P139-HD

DIGITAL AUDIO SYSTEM

BELL 204 / 212/ 412 INSTALLATION

MDL GA212 Rev A STC SR02270SE

G13000 P139-HD ROUTER
WEIGHT = 5 LBS MAX
POWER = 5 AMPS MAX
VOLTAGE = 14 - 32 VDC

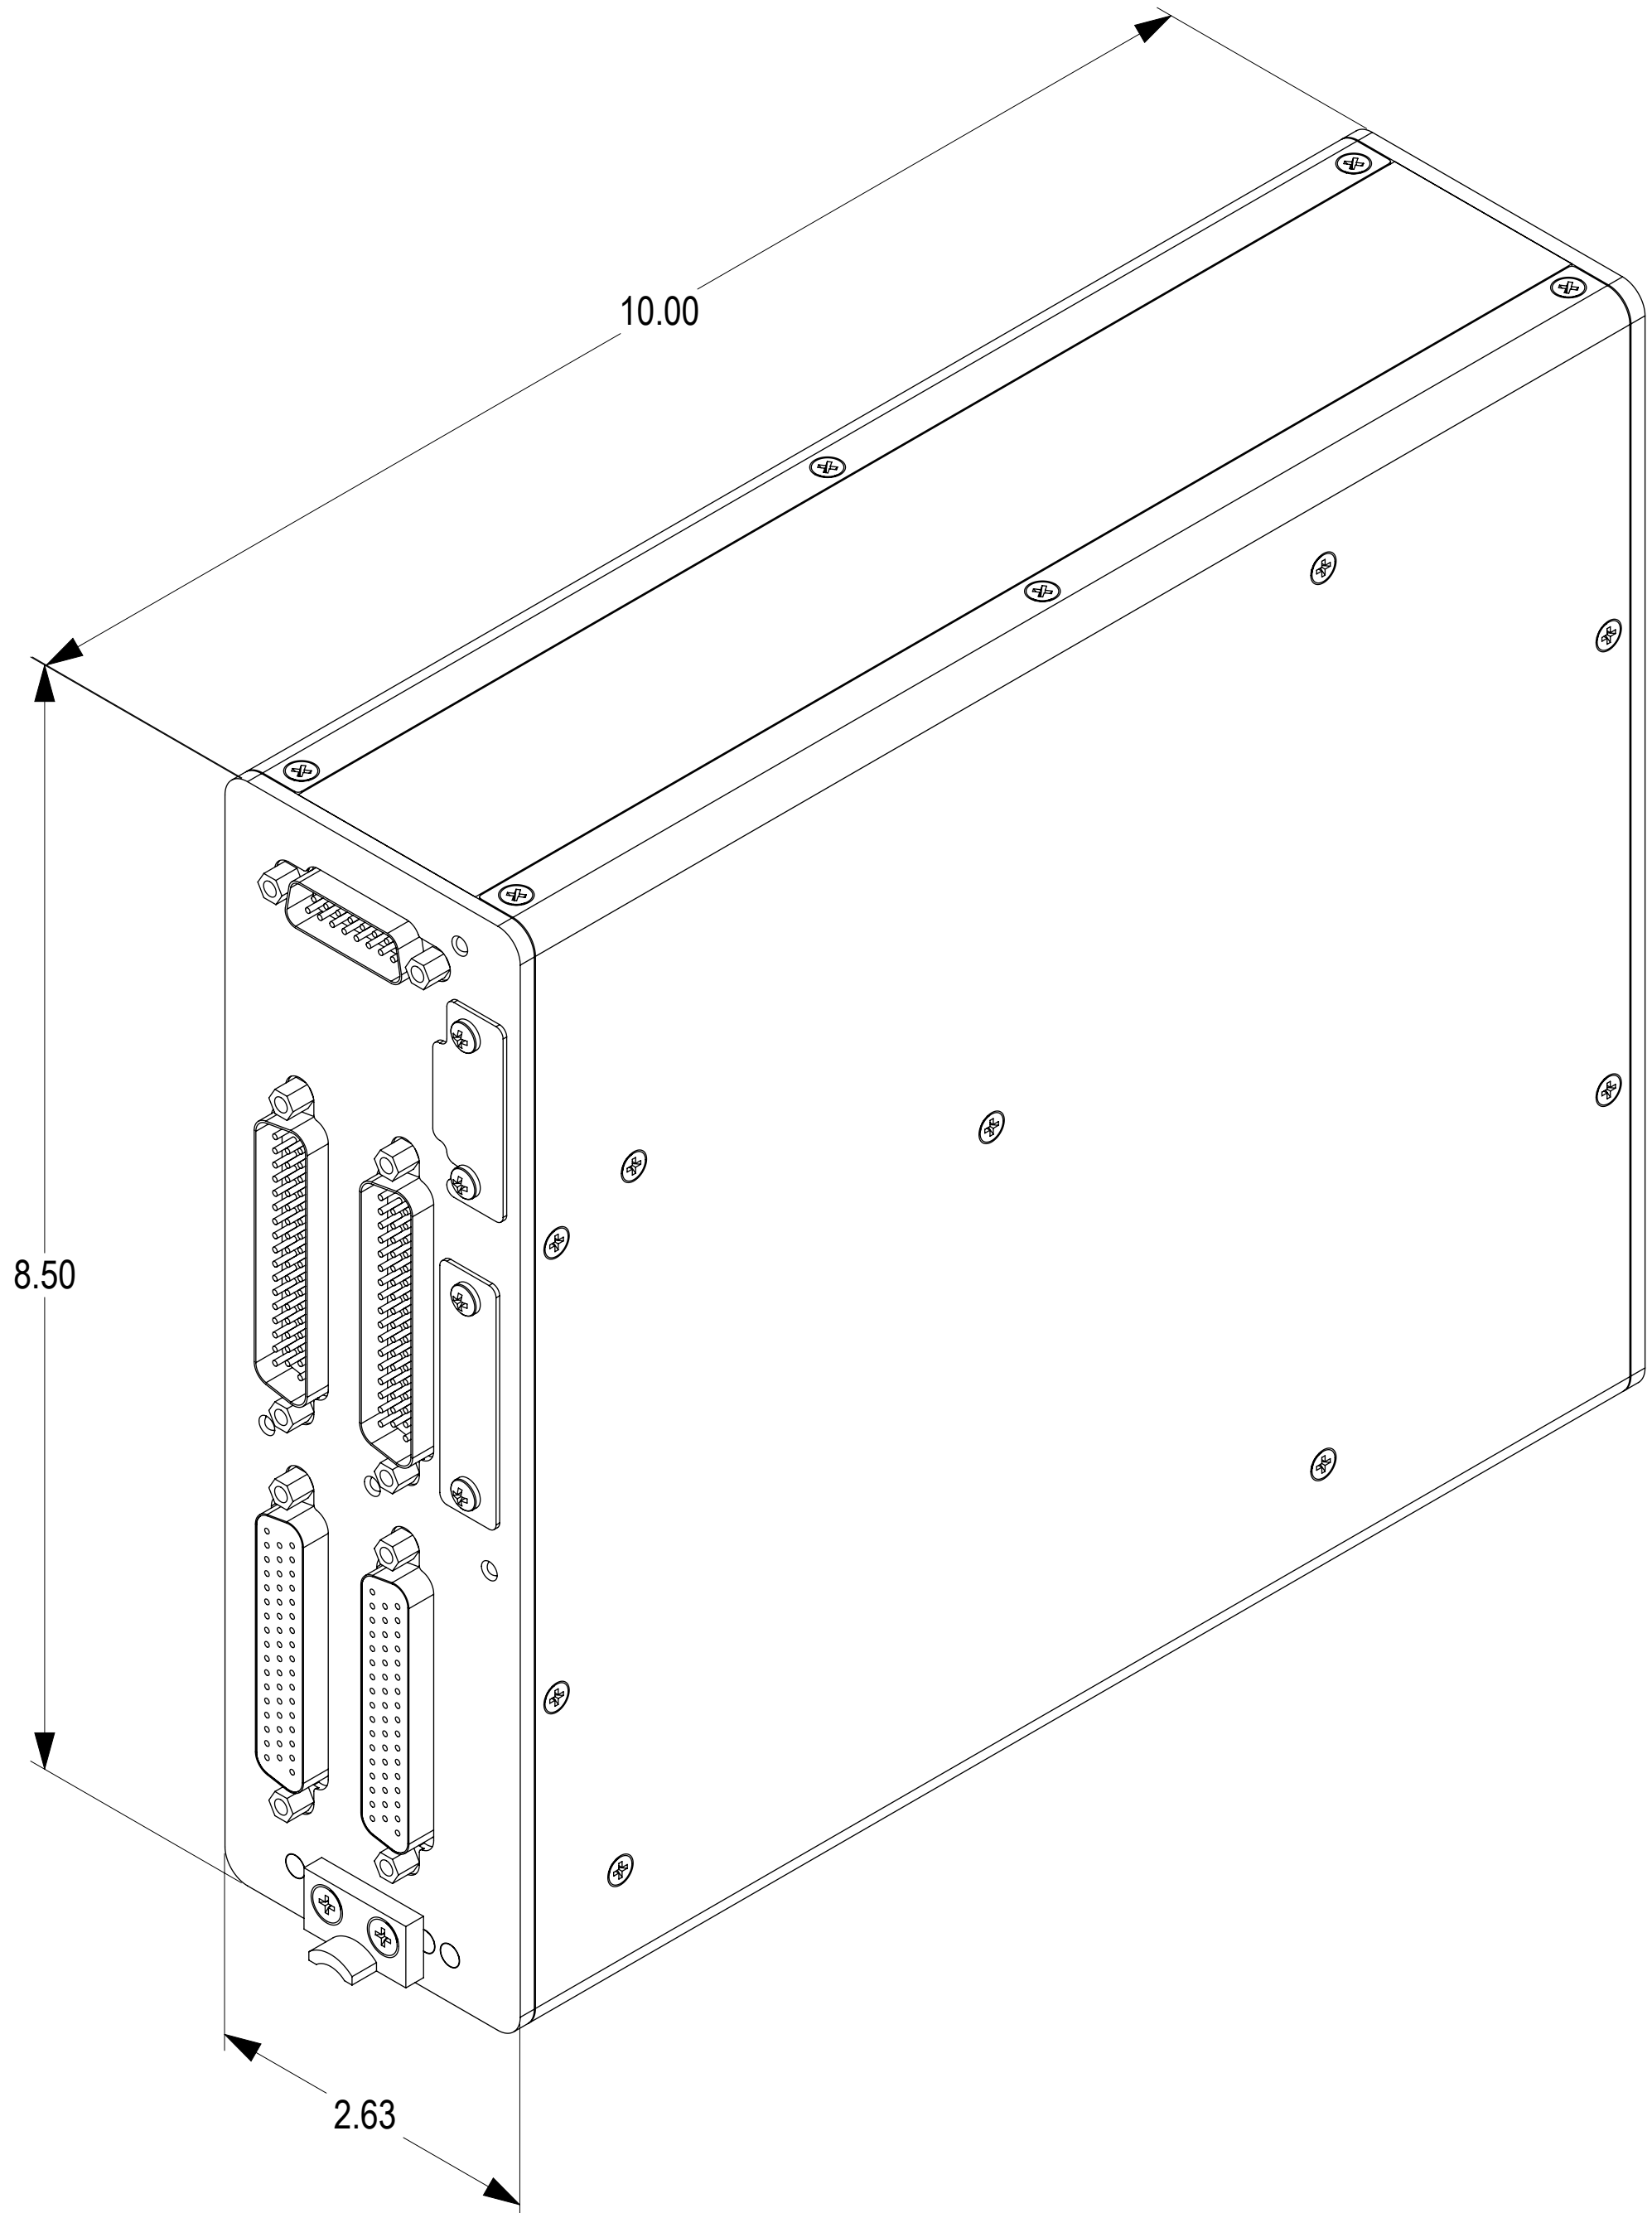
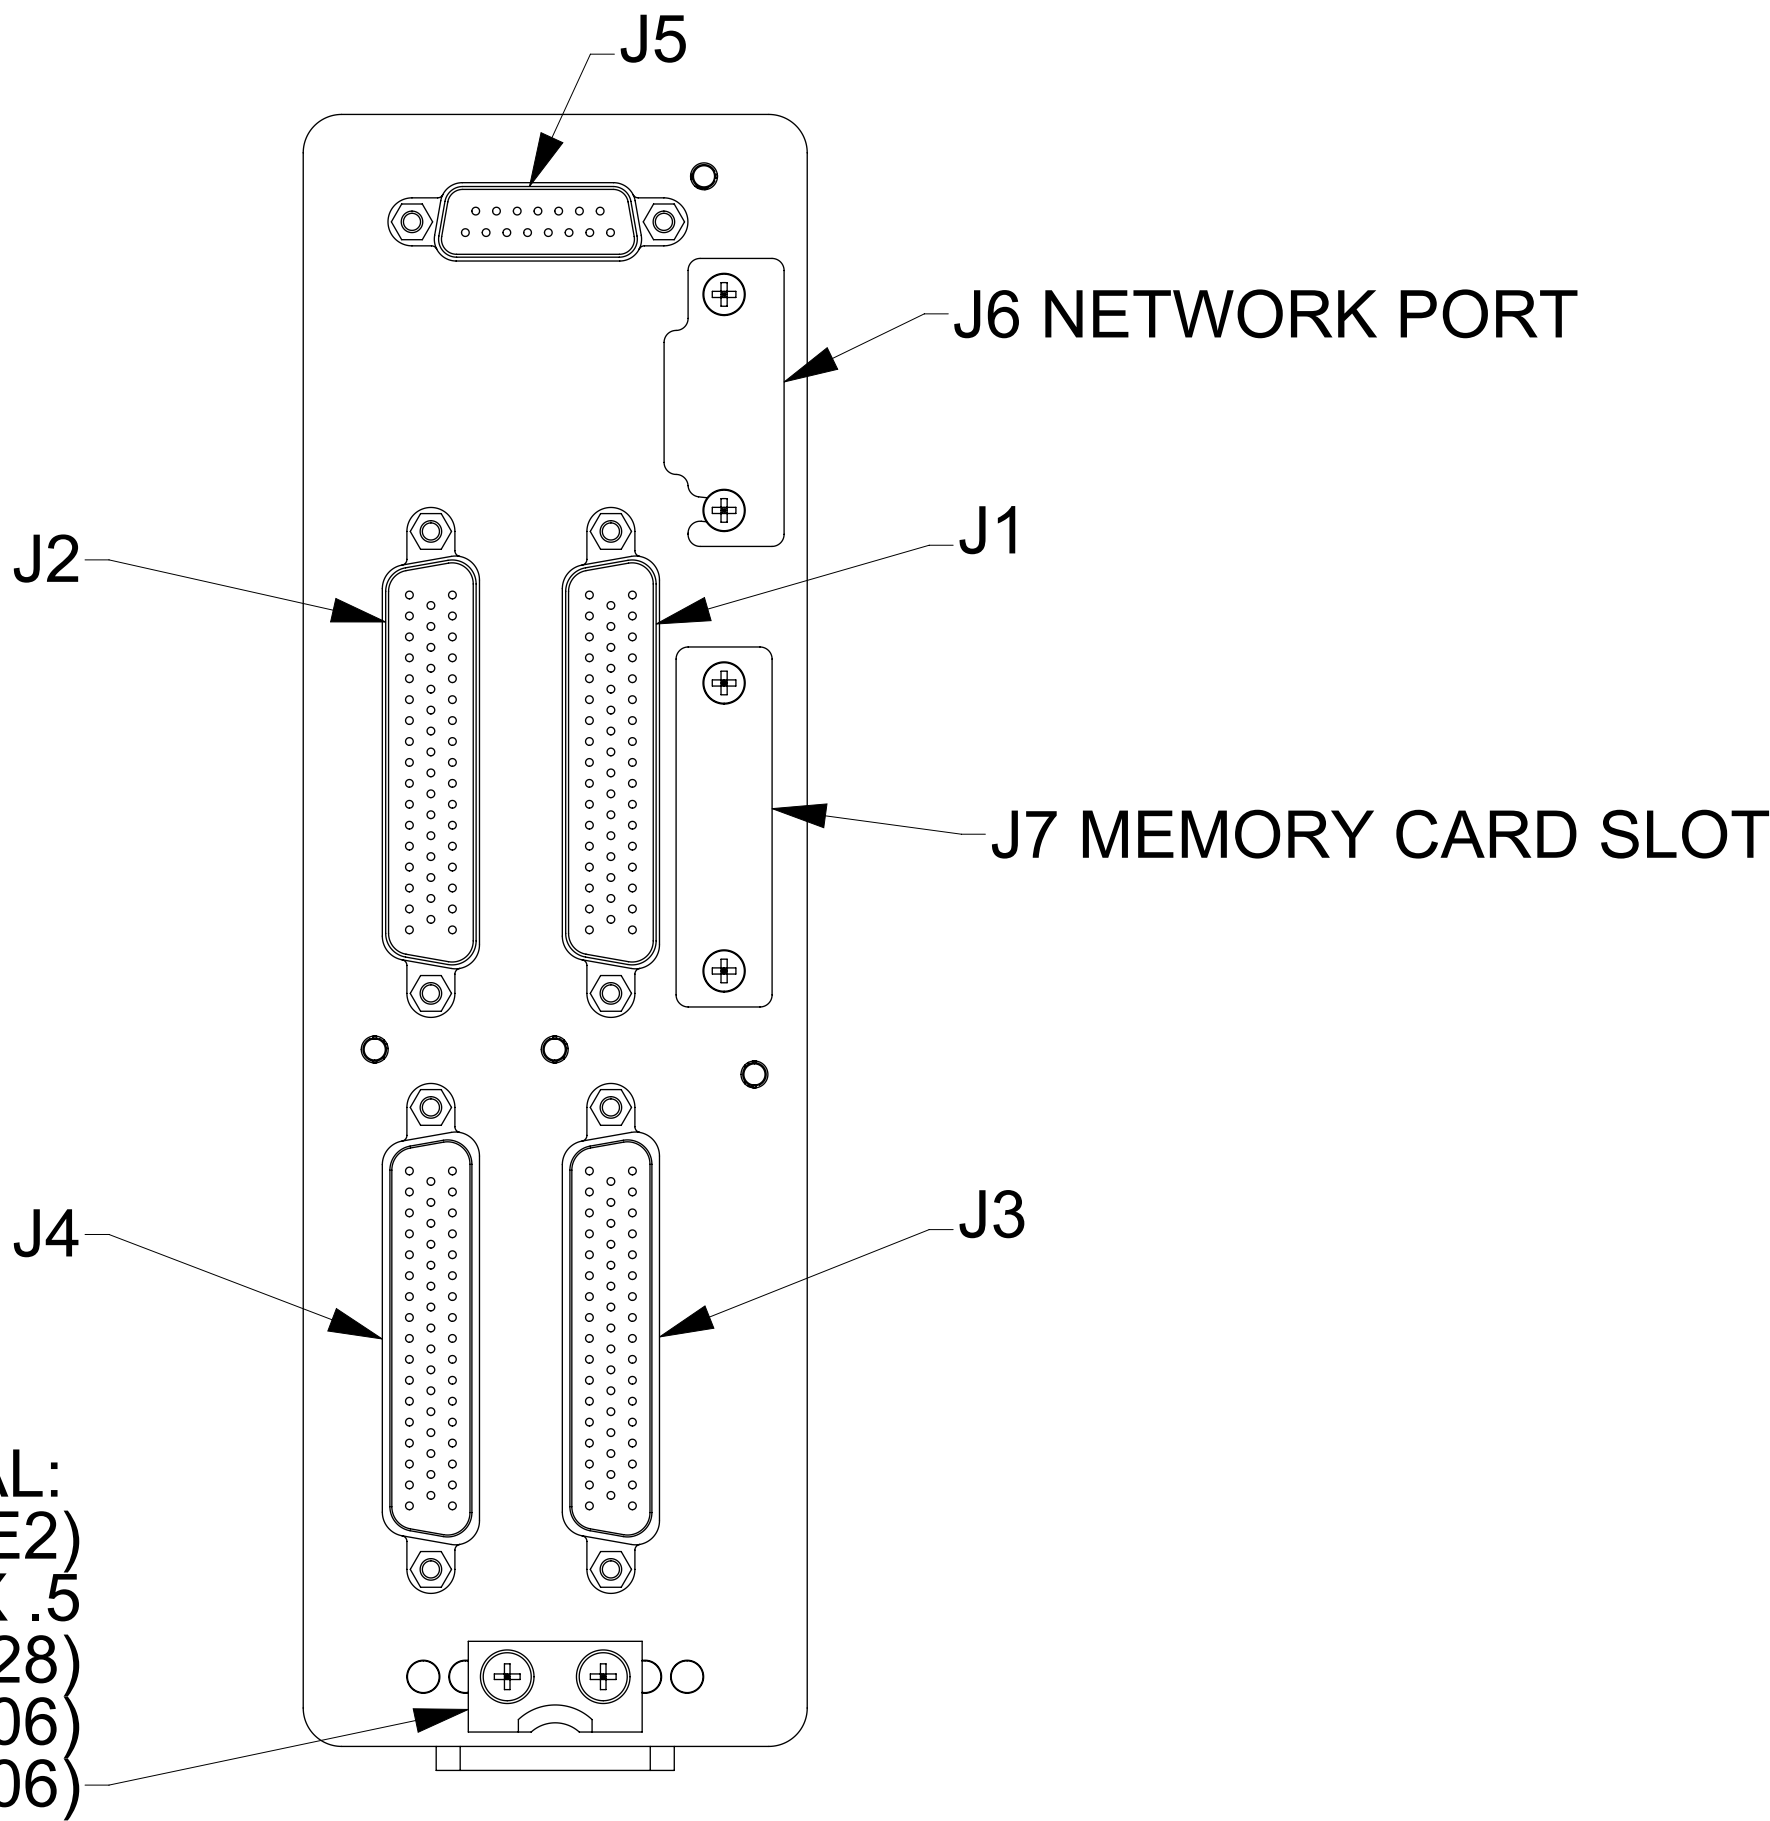
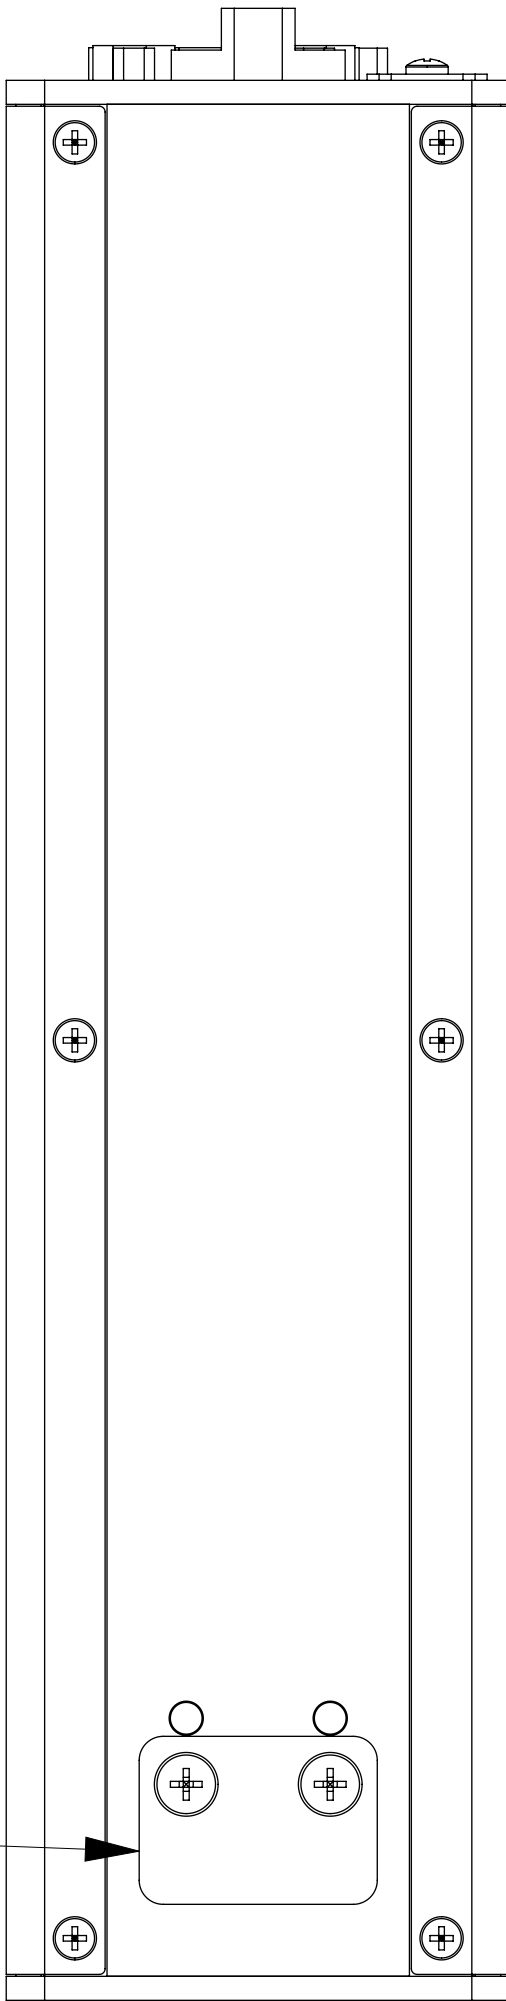
This ECO updates Audio Routers G13000 and G13160 to change the operating voltage from 10 – 30 VDC to 14 – 32 VDC.

REVISIONS		
REV	DESCRIPTION	APPROVED/DATE
A	REVISED LABEL ON J7	5/12/09 CLB
B	ADDED SINGLE BOARD CONFIGURATION NOTE	6/10/11 CLB
C	REVISED FRONT SCREWS FOR G13009 TRAY	1/13/12 CLB
D	ADDED OPTIONAL FRONT AND BOTTOM CLIPS FOR TRAY INSTALLATION	11/30/12 CLB
E	VOLTAGE RANGE WAS 10 - 30 VDC	08/13/14 CLB

GNET EXTERNAL POWER:

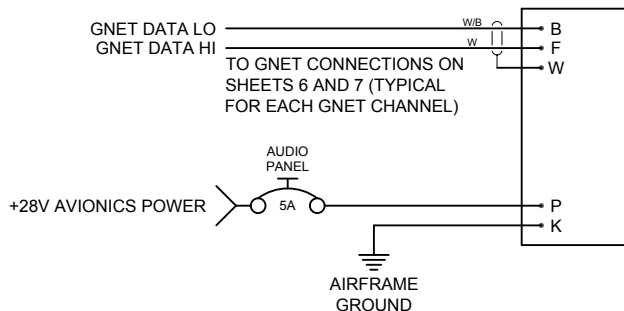
G13004 has been updated to change the headset numbering scheme and to add external power for additional control panels.

IF THE AUDIO SYSTEM HAS MORE THAN 6 CONTROL PANELS AN EXTERNAL POWER SOURCE FOR THE ADDITIONAL PANELS MUST BE PROVIDED. UP TO 12 ADDITIONAL CONTROL PANELS MAY BE POWERED FROM EACH EXTERNAL 5A BREAKER.

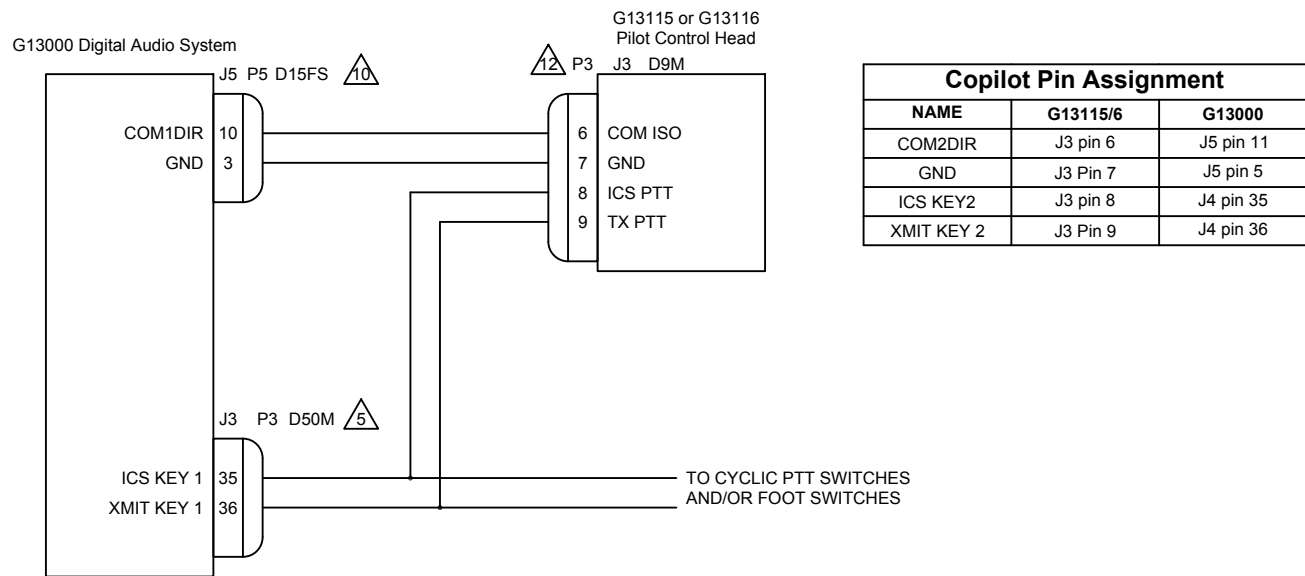
G13004: Rewrote EMERG/NORMAL notes on sht 13 for clarity.

The G13115 and G13116 control heads thave two electromechanical toggle switches on the front panel; an EMERG/NORMAL locking toggle switch, and a 3-position momentary switch for ICS/OFF/TX PTT. When each switch is "on" the appropriate pin on the J3 connector is connected to GND, pin 7.

The above wiring illustrates the use of the EMERG/NORMAL switch on the Pilot's G13116/G13116 control head to control the Emergency Mode operation for the pilot headset. The operation of the Digital Audio System in Emergency Mode is detailed in NOTE 8 on G13004 sheet 1.
